# CITY OF ALBUQUERQUE

**RE: 5400 Menaul Blvd NE**  
**Grading and Drainage Plans**  
**Engineer's Stamp Date: 09/08/21**  
**Hydrology File: H18D074**

Based upon the information provided in your submittal received 09/08/2021, the Grading & Drainage Plan **is not** approved for Building Permit, Grading Permit, SO-19 Permit, and for action by the DRB on Site Plan for Building Permit. The following comments need to be addressed for approval of the above referenced project:

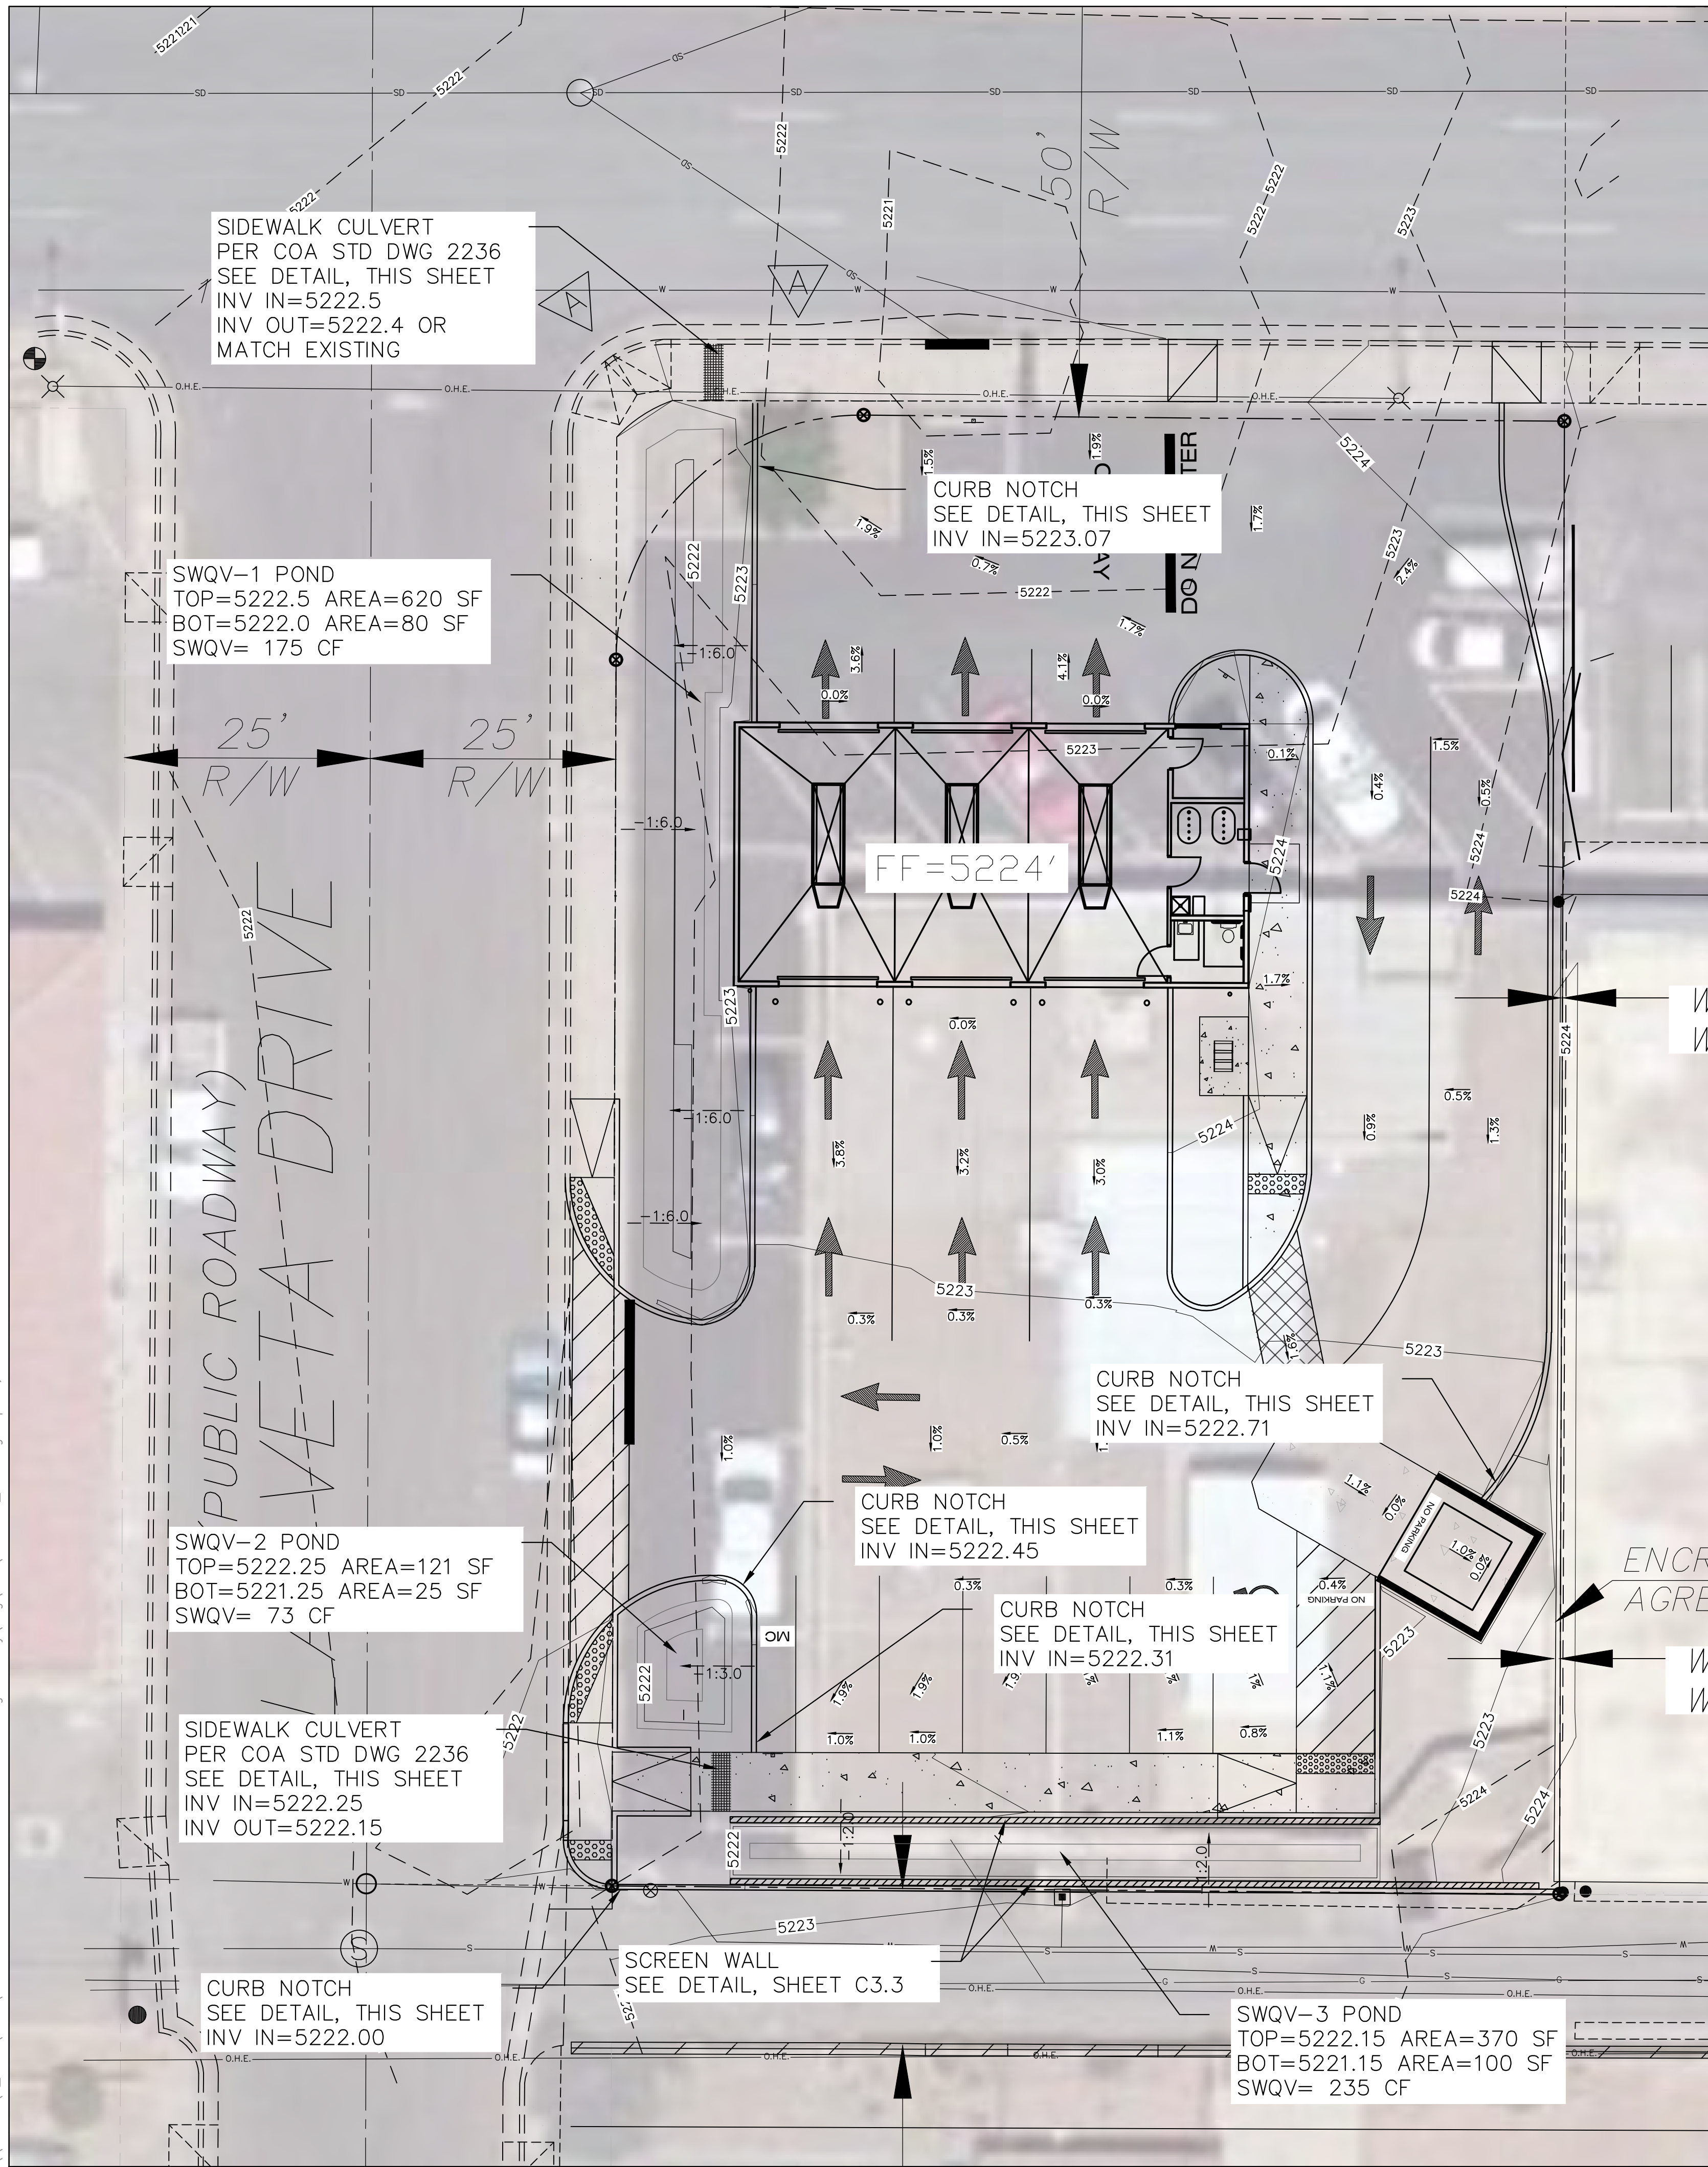
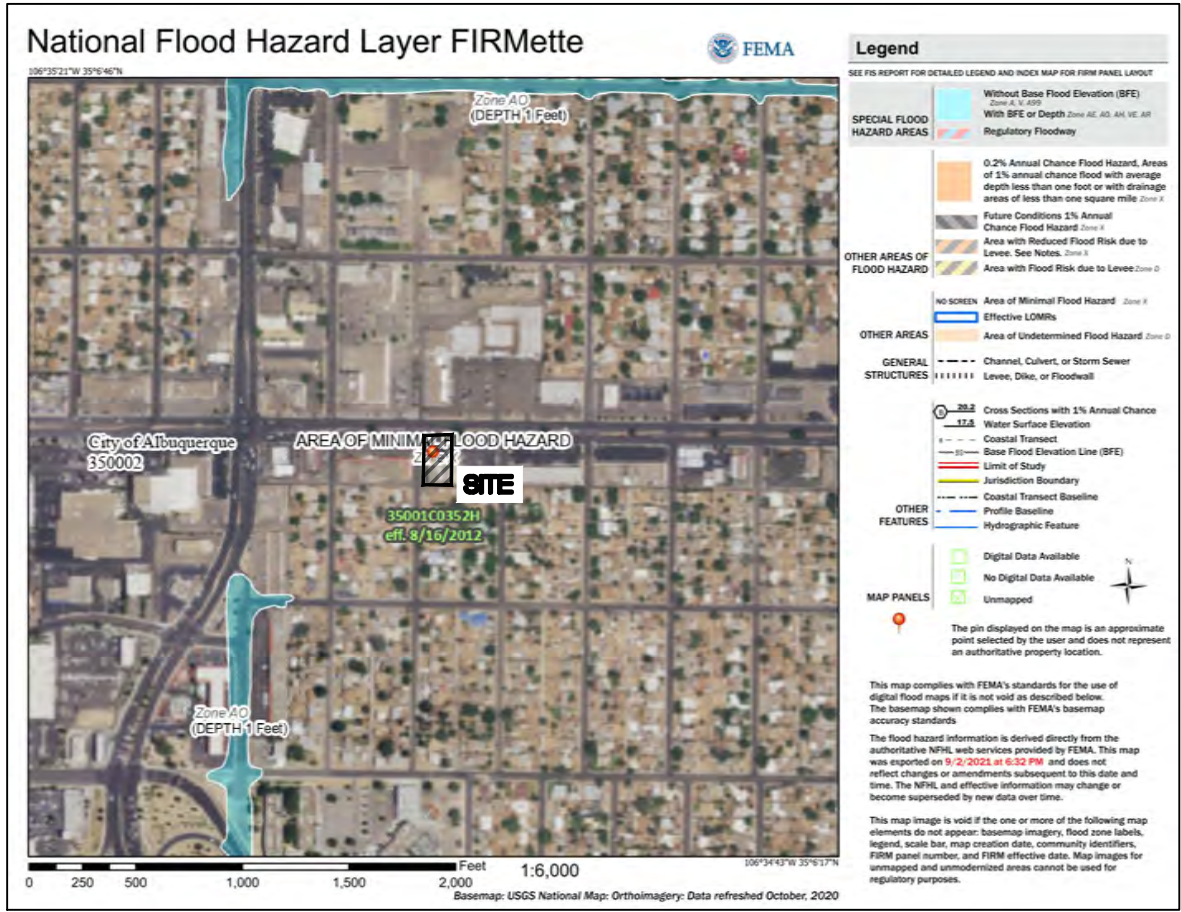
1. Please provide a vicinity map showing the location of the site. Typically this is the Zone Atlas. This can be downloaded in pdf format from the City of Albuquerque's website.
2. Please provide the weir calculations, per DPM Article 6-16(A), for the curb cuts and sidewalk culverts. A coefficient of 2.7 is typically used for the weir equation  $Q = CLH^{2/3}$ .

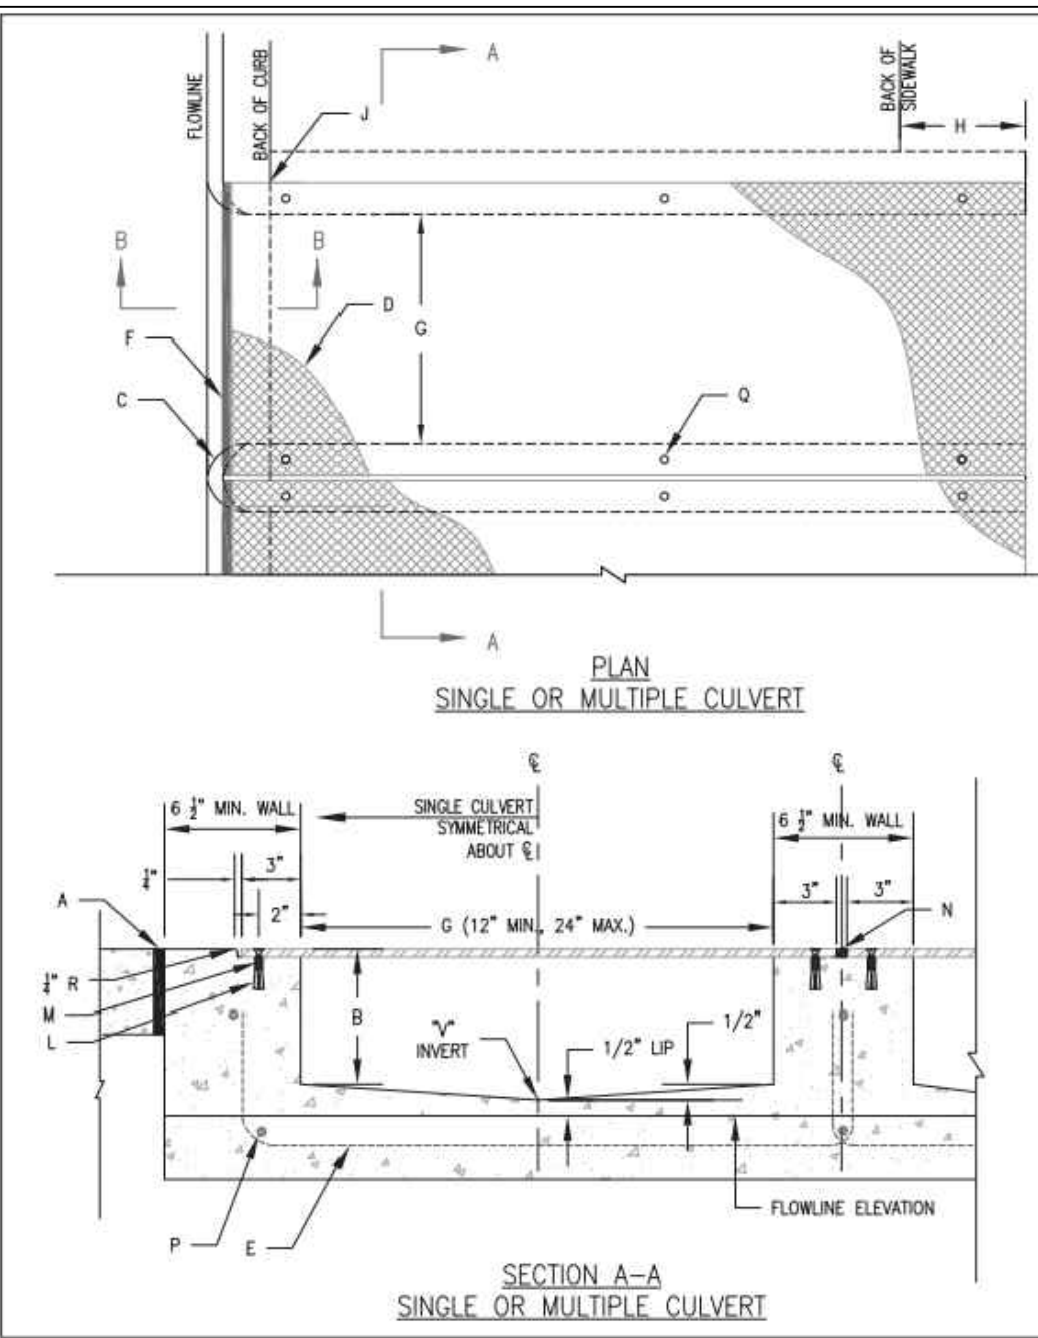
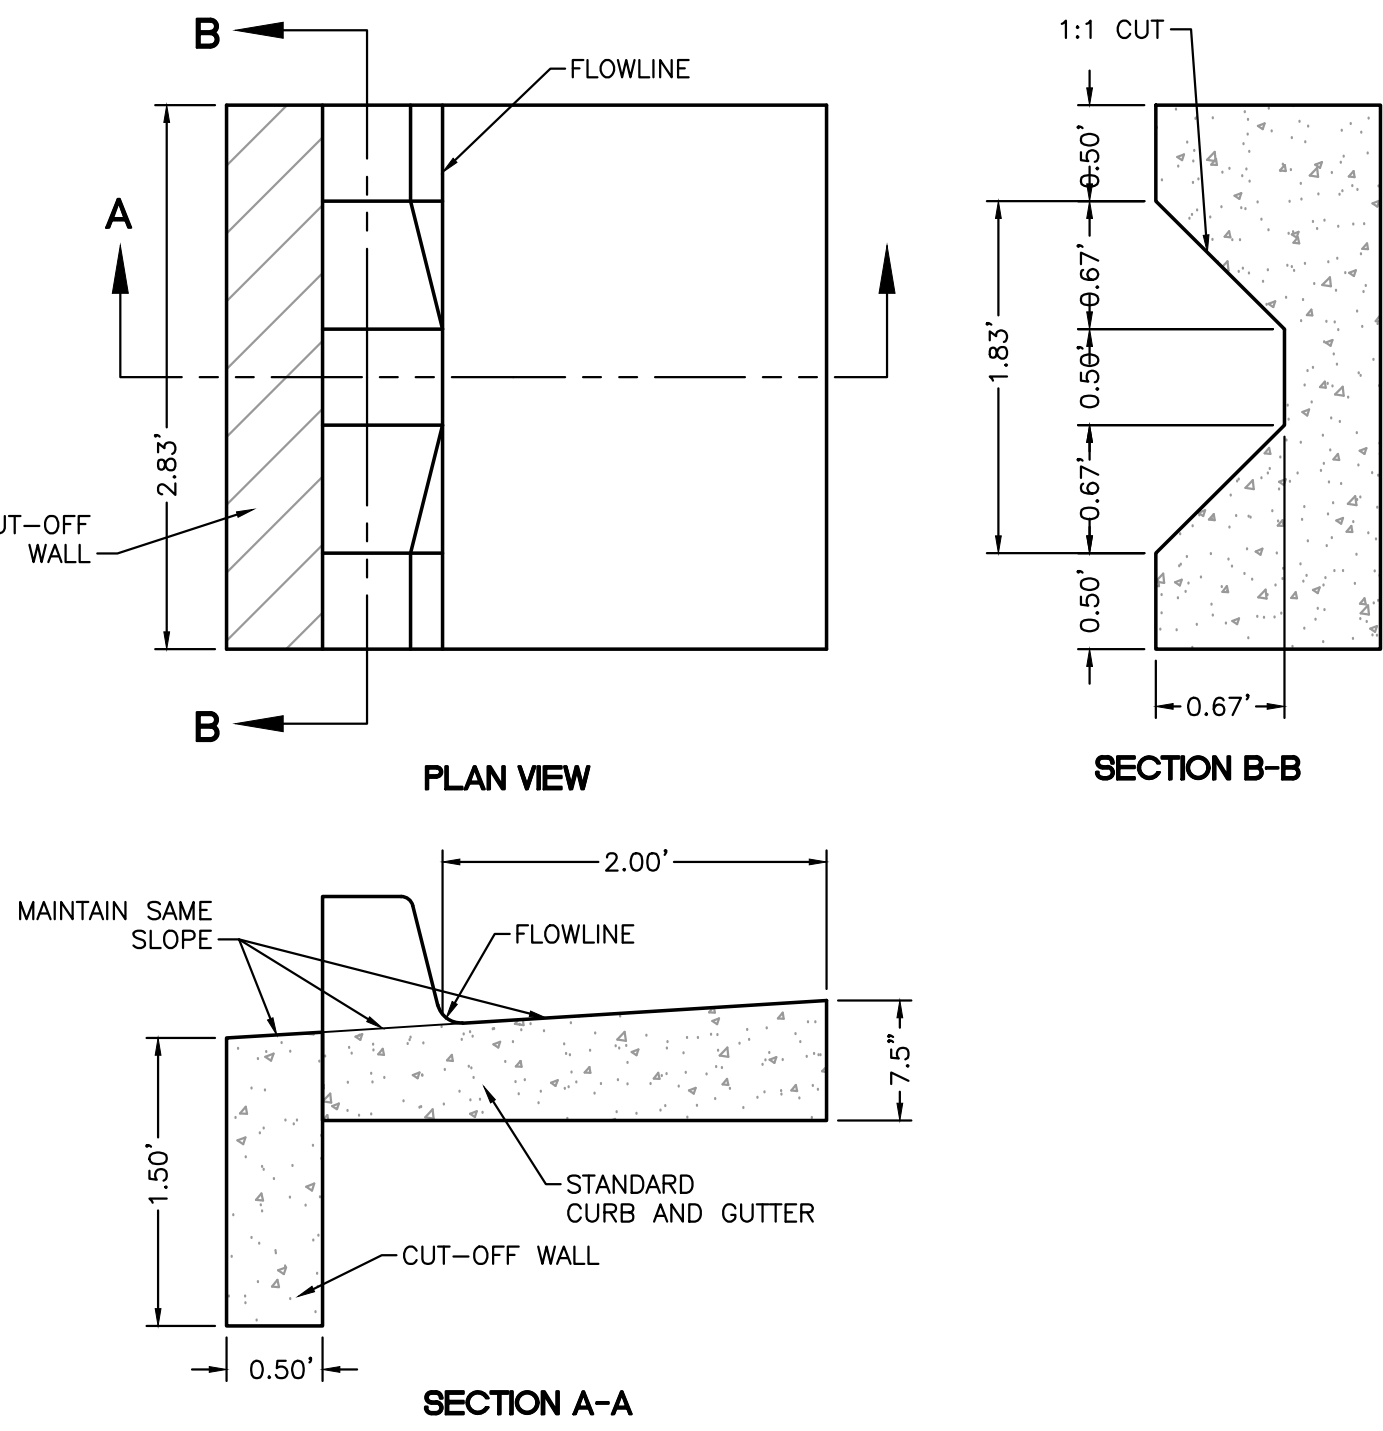
3. Please contact Transportation. There are some existing drives that need to be closed on both Menaul and La Veta. Also, the ADA ramps may need to be brought up to current standards on Menaul.
4. Please show and label on both Menaul and La Veta where the existing drives are to be closed. This can be placed here or on C3.3.

5. Please update the SO-19 Notes. See Attachment.
6. The Sidewalk Culvert detail does not need to be shown. The correct COA Standard Drawing has been called out.
7. Please add a note to the sidewalk culvert on the southwest corner of the site as “a private on-site sidewalk culvert”. The City will only inspect the one in Menaul’s R.O.W.
